MASTER COACHBUILDER INFORMATION UPDATE

Date: December 15, 2014 **Bulletin Number:** XTS 39 **Subject:** Vehicle Labeling Clarifications

SAMPLE: CMC Tire Placard Label for W30 chassis

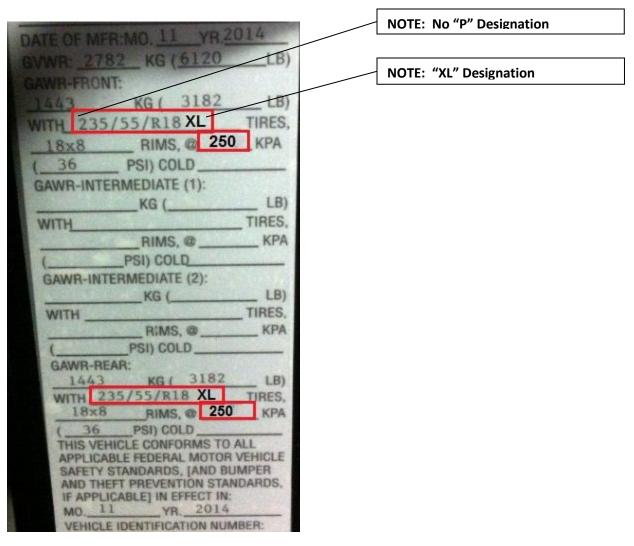
The current tire released for the XTS Professional Vehicle is the "Continental ContiPro Contact", size "235/55R18 XL". Please note there is no "P" prefix designator in the size identification number and there is an "XL" designation at the end.

Also on both the tire and final certification labels, the tire pressure needs to match the incomplete vehicle label as stated in KPA along with PSI.

Please see the W30 chassis samples below.
